Moorebank Intermodal Precinct West – Stage 2 Modification 2

Changes to construction related conditions
State Significant Development Modification Assessment
(SSD 7709 MOD 2)

Published by the NSW Department of Planning, Industry and Environment

Figure 5 | Indicative location of maintenance tracks (highlighted yellow) (Base source: MOD 2 Application)

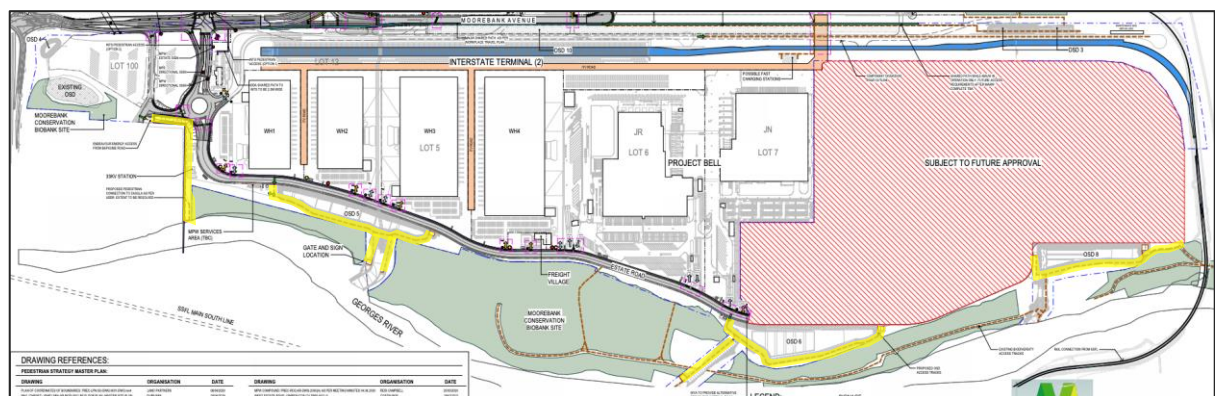
The Department notes Condition B2 (g) was imposed based on the Department's original assessment, which identified the need to address edge effects and ensure the design of the fill batters provides stability, mitigates visual impacts, provide for maintenance activities and does not impact on adjacent lands, including biodiversity offset areas and the riparian corridor.

However, TfNSW noted that the indicative Masterplan submitted with the modification showing the access tracks (shown in Figure 5) does not appear to form part of this application, and therefore it has not been assessed and should be disregarded. The Department agrees, noting the Applicant has advised that this plan is indicative only, and that further changes may be made to the plan prior to it being submitted in accordance with Condition B2. The Department has not assessed the plan as part of this modification and recommends a condition clarifying that the indicative plan does not form part of the modification approval.

The Department is satisfied that necessary maintenance activities can be carried out as long as there are no impacts to the adjacent riparian corridor. Therefore, there is no need to provide a separate maintenance access track and the Department agrees with the Applicant that unnecessary tracks may lead to additional unnecessary impacts. However, the exact extent of the necessary access tracks will be a matter for determination at the time of submitting the amended development layout drawings.

The Department considers the above condition provides the Applicant with flexibility to only provide tracks where necessary and clarifies that the provision of the tracks is to be determined based on the need to protect the riparian corridors and adjoining sites.
